ADDENDUM

Addendum No.: **TWO (002)**
Project: KCKCC Field House Addition

Project No.: 22060A
Date: October 23, 2023

SP1.01

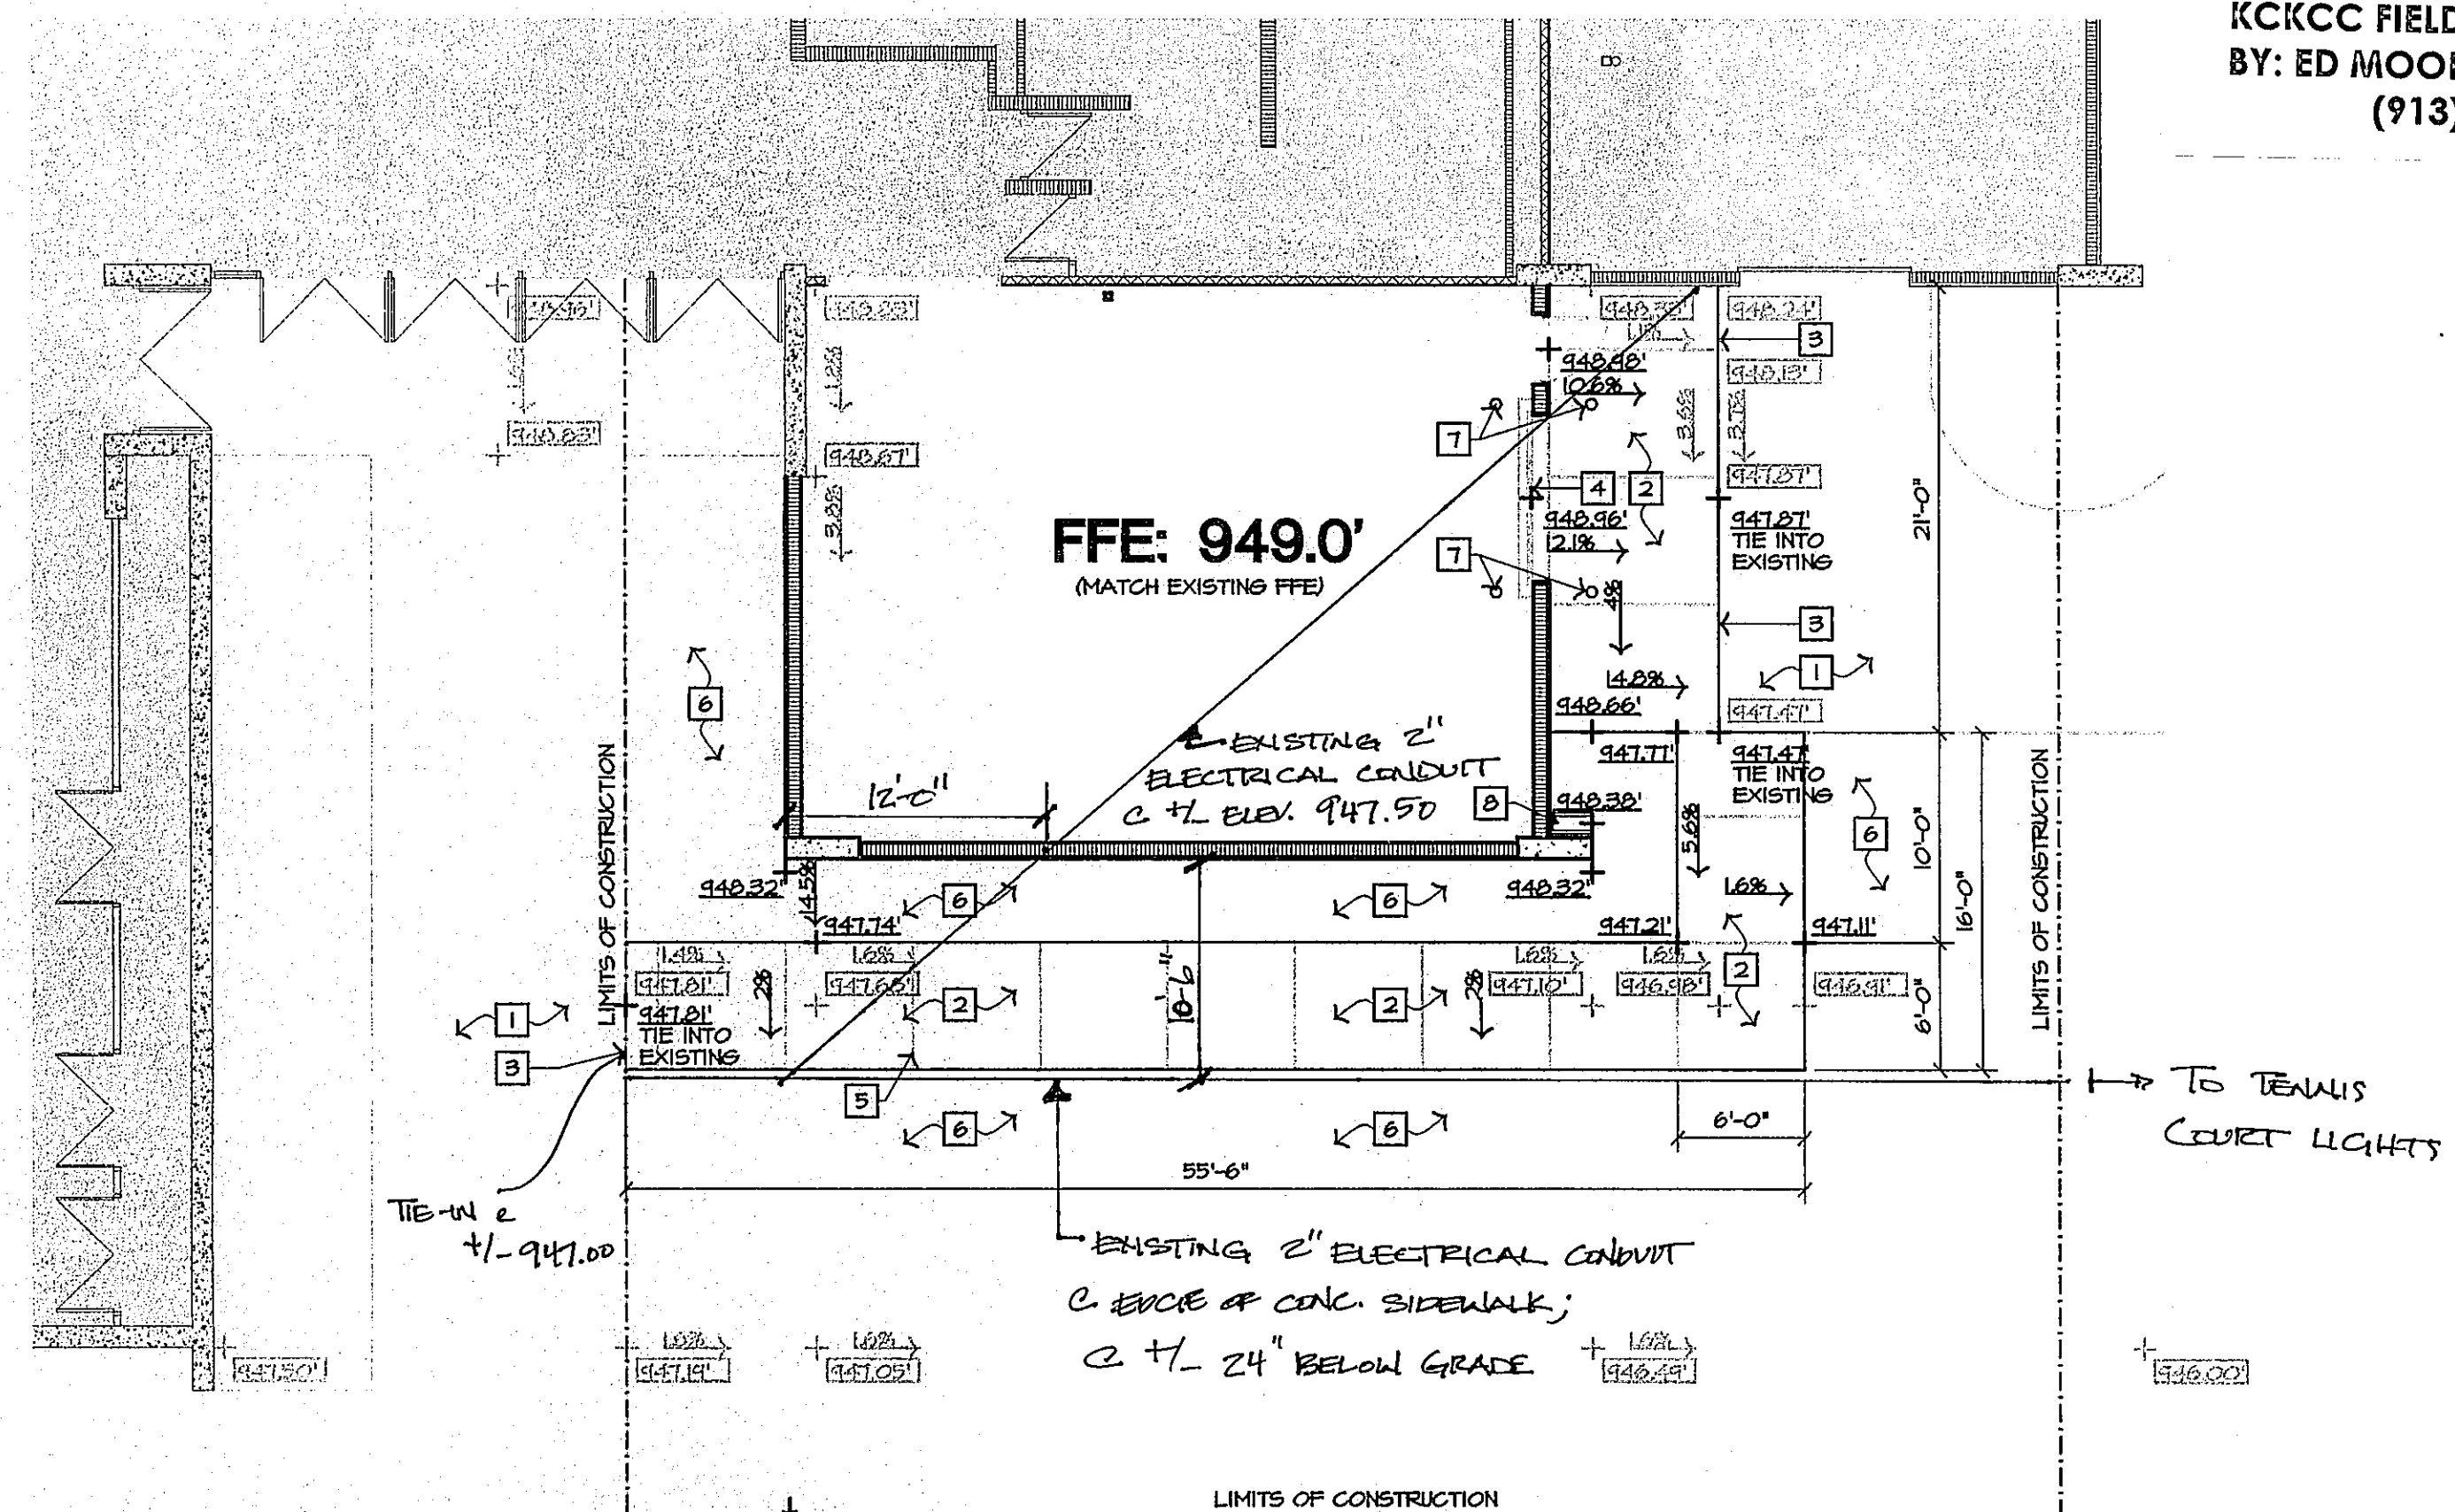
- i. As-Built of the current weight room are included here for reference. Please note on Sheet SP1.01 the electrical conduit that runs under that portion of the building and under the corner of the new addition. An approximate height of that conduit is included on the sheet.

- A. Key Notes 9, 10, & 11 on Sheet SP1.01 provide information on regrading around the building. The design team did not calculate fill/removal from the site so grading contractors need to take a look at the site and confirm what will be needed for this scope of work. See the meeting notes from the Pre-Bid Conference for more information.

KCKCC Field House Addition
ADDENDUM TWO
SHEET S2.02
WSKF Architects
Bob D Campbell & Co.

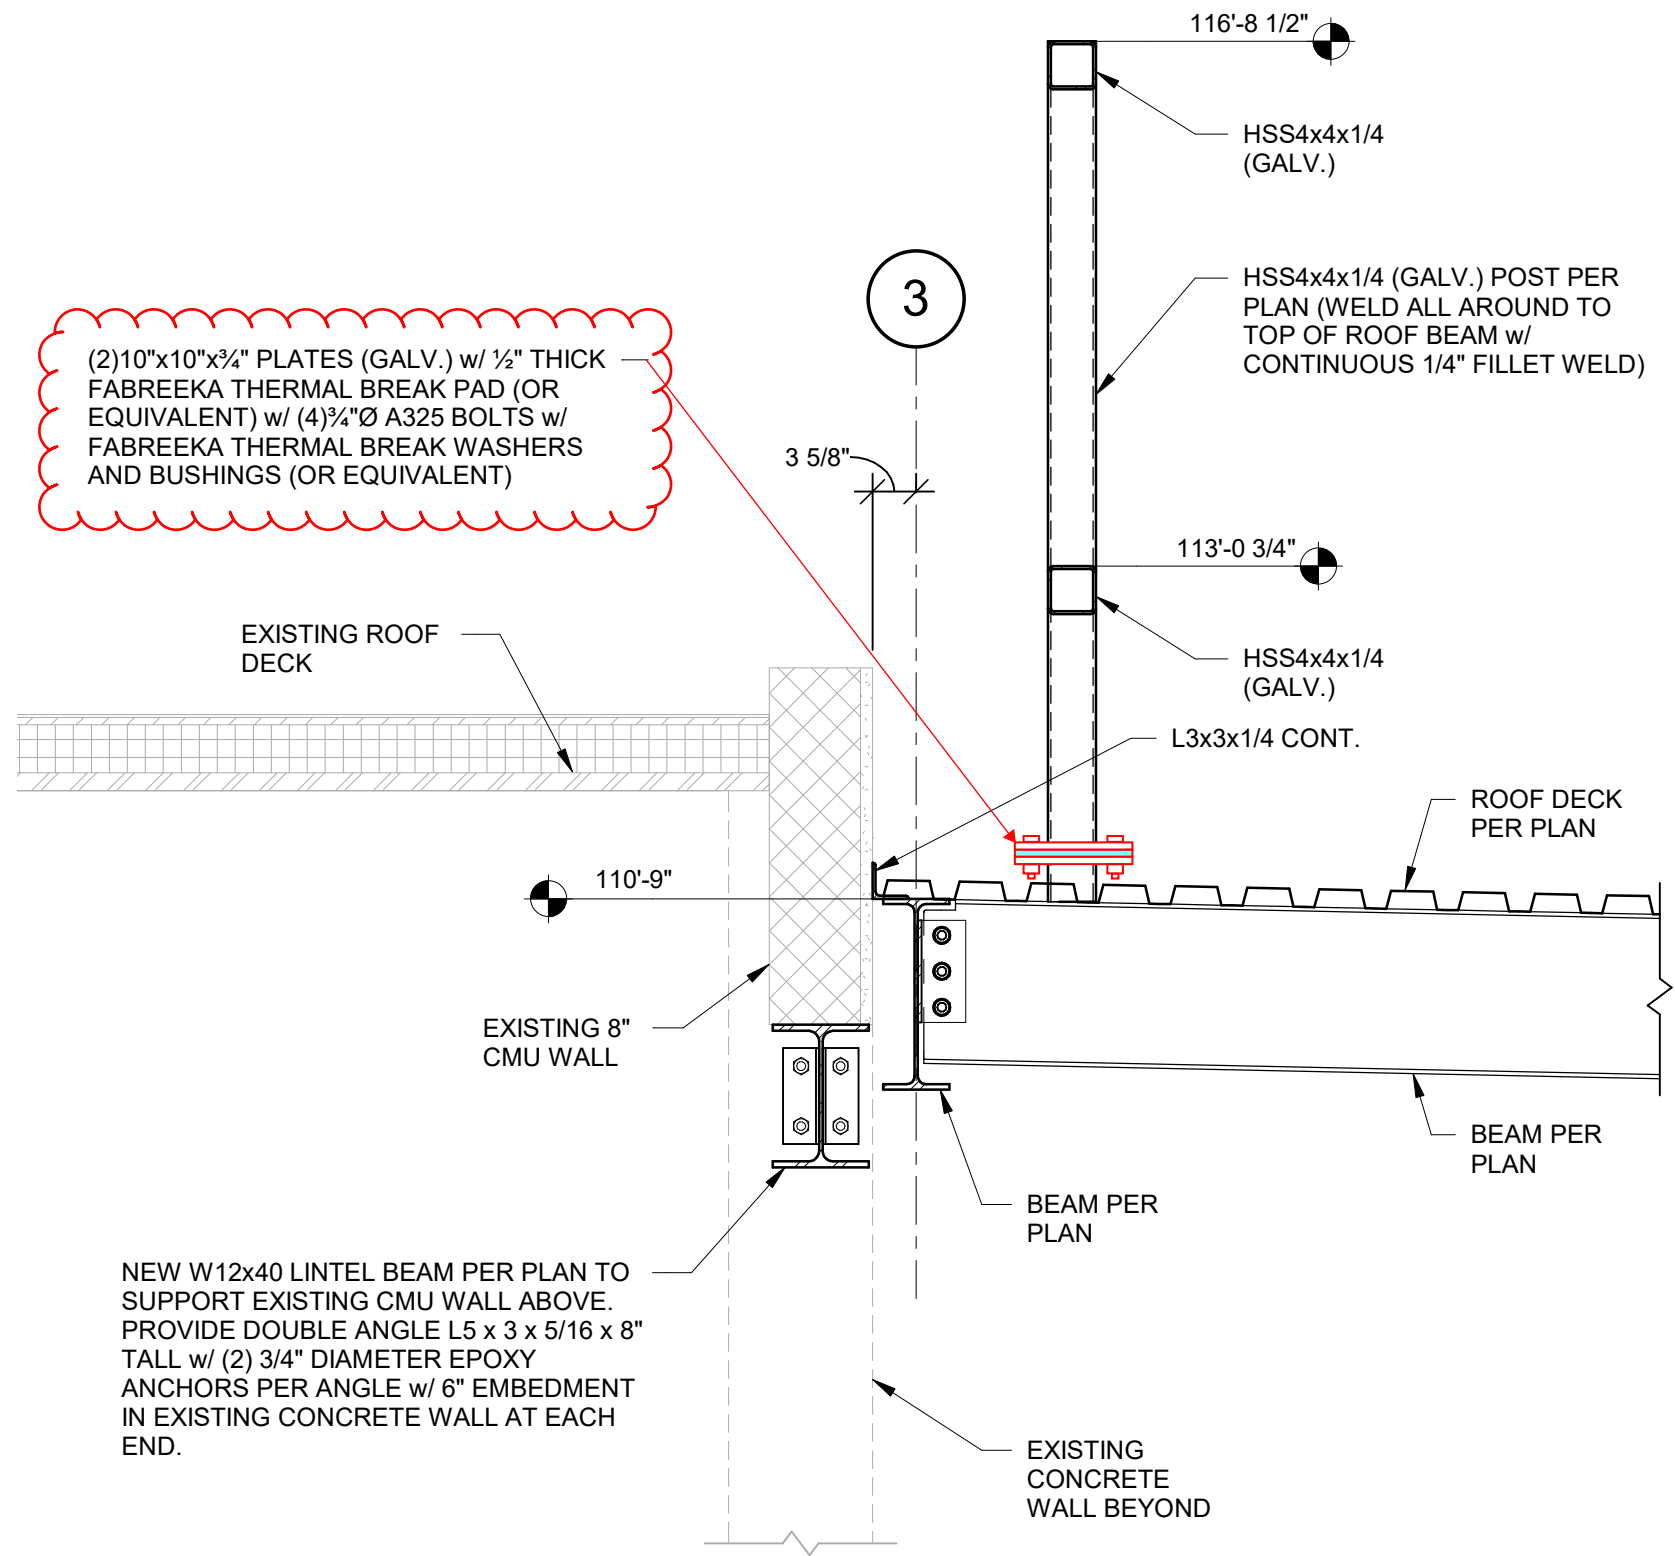
- i. Revised Section 4 of the RTU Screen to show Alternate #3 design. Refer to attached sketch sheet.

- C. Alternate No. Three - RTU Screen Thermal Break:
 - 1. Base Bid Item: The base bid stipulates that the vertical HSS tube steel posts for the RTU screen are to be welded directly to the top flange of the steel roof beams with no thermal break detail included.

- 2. Alternate Item: The alternate bid separates each post into two pieces that are separated by a thermal break material. The lower piece is a shorter HSS post with a $\frac{3}{4}$ " x 10" x 10" cap plate and the upper piece is a taller HSS with a $\frac{3}{4}$ " x 10" x 10" base plate. The cap plate and the base plate are to be separated by a $\frac{1}{2}$ " thick Fabreeka thermal break pad and bolted together with four $\frac{3}{4}$ " diameter A325 bolts. All steel is to be hot-dip galvanized.
